North Central Texas
Council of Governments

**Recommended Amendments to the
2024 International Residential Code**
North Central Texas Council of Governments Region

Fig R327.3

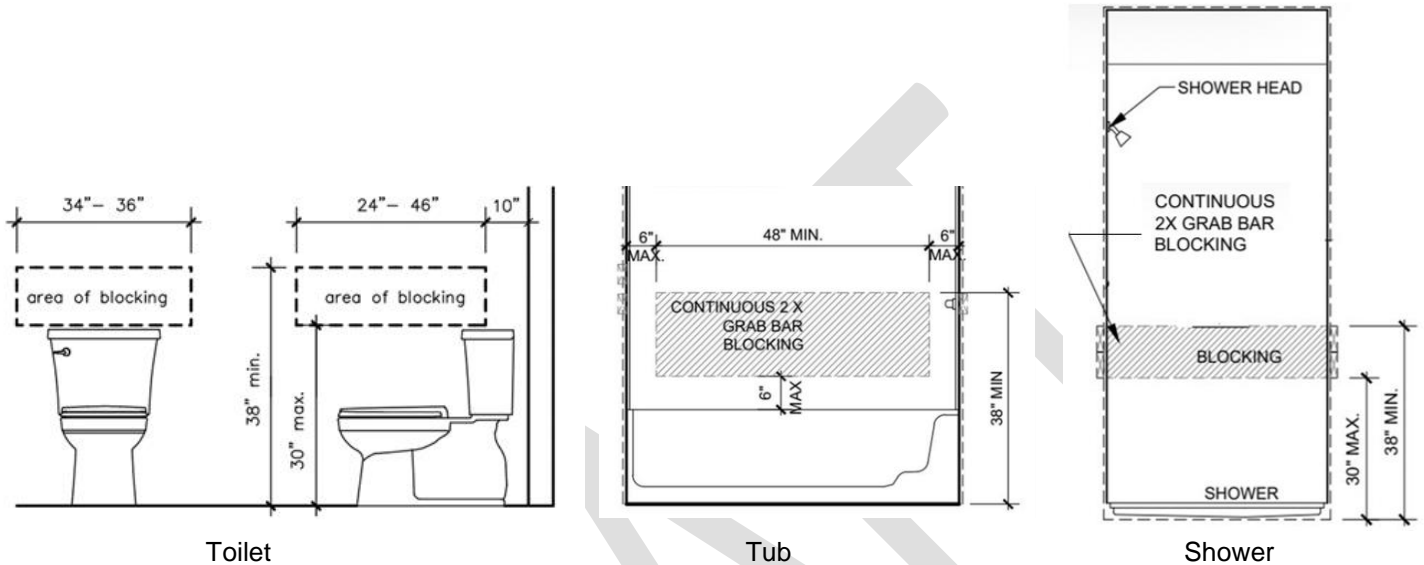
*****R327.3 Blocking Locations; add to read as follows:**

R327.3 Blocking locations. Required at one toilet at grade level with blocking installed at rear wall and one wall adjacent to toilet and at one tub or shower at grade level. Blocking as shown in Figure R327.3.

(Reason: Blocking at initial construction allows for ease of use for future grab bar installation if desired for homeowners. Ties into Dallas Builders Association of Universal Design Elements concepts for CAPS (Certified Aging in Place Specialists) professionals.)

Fig R327.4

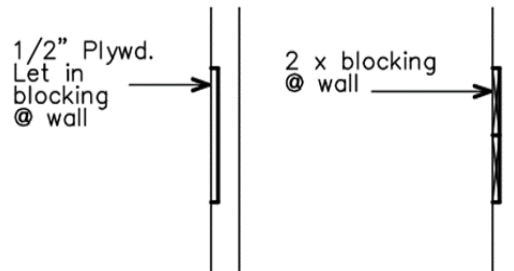
*****R327.4 Wall Blocking; add to read as follows:**

R327.4 Wall Blocking. Blocking may be 1/2" plywood or 2 x solid wood blocking or equivalent, flush with wall as shown in Figure R327.4.

(Reason: Blocking at initial construction allows for ease of use for future grab bar installation if desired for homeowners. Ties into Dallas Builders Association of Universal Design Elements concepts for CAPS (Certified Aging in Place Specialists) professionals.)

****Figure R602.6.1; delete the figure and insert the following figure:**

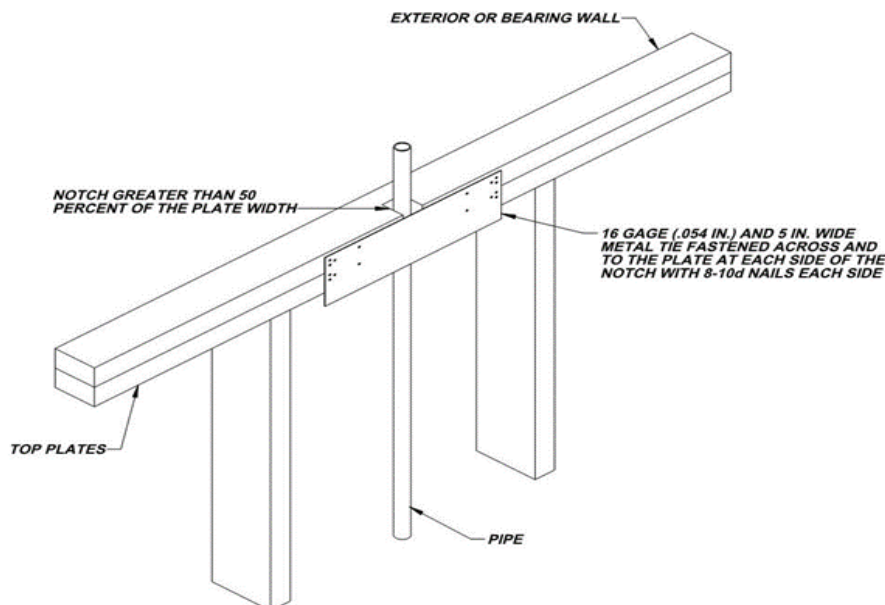
R602.6.1 Drilling and notching of top plate. When piping or ductwork is placed in or partly in an exterior wall or interior load-bearing wall, necessitating cutting, drilling or notching of the top plate by more than 50 percent of its width, a galvanized metal tie not less than 0.054 inch thick (1.37 mm) (16 Ga) and ~~4-½ inches (38 mm)~~ 5 inches (127 mm) wide shall be fastened across and to the plate at each side of the opening with not less than eight 10d (0.148 inch diameter) having a minimum length of 1 ½ inches (38 mm) at each side or equivalent. Fasteners will be offset to prevent splitting of the top plate material. The metal tie must extend a minimum of 6 inches past the opening. See figure R602.6.1. {remainder unchanged}

(Amendment to 2021 IRC carried forward to 2024 IRC also provides additional assurance of maintaining the integrity of the framing by spreading the nailing pattern.)
